Planning Application 2014/4679/P : 140-146 Camden Street, London, NW1 9PE

Re: The Proposed Development at 140-146 Camden Street, London NW1- Daylight & Sunlight review

Review of Results for 1a and 1b Bonny Street

PLATE 01 – GROUND AND FIRST FLOOR OF 1A BONNY STREET – INTERNAL MEASURED SURVEY

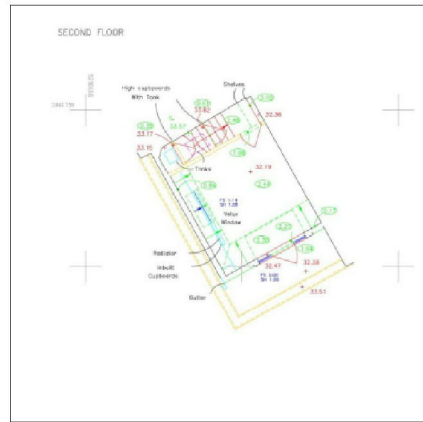
The DD results include a review of three rooms – one located on each level starting at grade. Two of the rooms assessed breach the guidelines i.e. a pass rate of 33% has been recorded. The supporting contour plots (Appendix G of the Anstey Horne report), highlight the location and assumptions as to the internal subdivision of the rooms behind those apertures facing the site. This does not, however, reflect the real position and therefore the extent of the daylight assessment is totally unreliable. The two images below (Plate 01 and Plate 02) highlight the true internal arrangement and dimensions of 1a Bonny Street. Note that there is both a kitchen and living room located on the ground floor.

- An update and review of the Daylight Distribution assessment based on the real internal layouts for both 1a and 1b Bonny Street;
- That the Average Daylight Factor assessments be undertaken (as per Camden Planning Guidance) to appreciate the daylight availability within the room space behind the apertures;
- That a cutback assessment be undertaken to the proposal in order to respect the Vertical Sky Component to 1a Bonny Street;
- That a cutback assessment be undertaken to understand the extent of the scheme massing which is causing the significant changes to the winter sunlight to 1a Bonny Street.
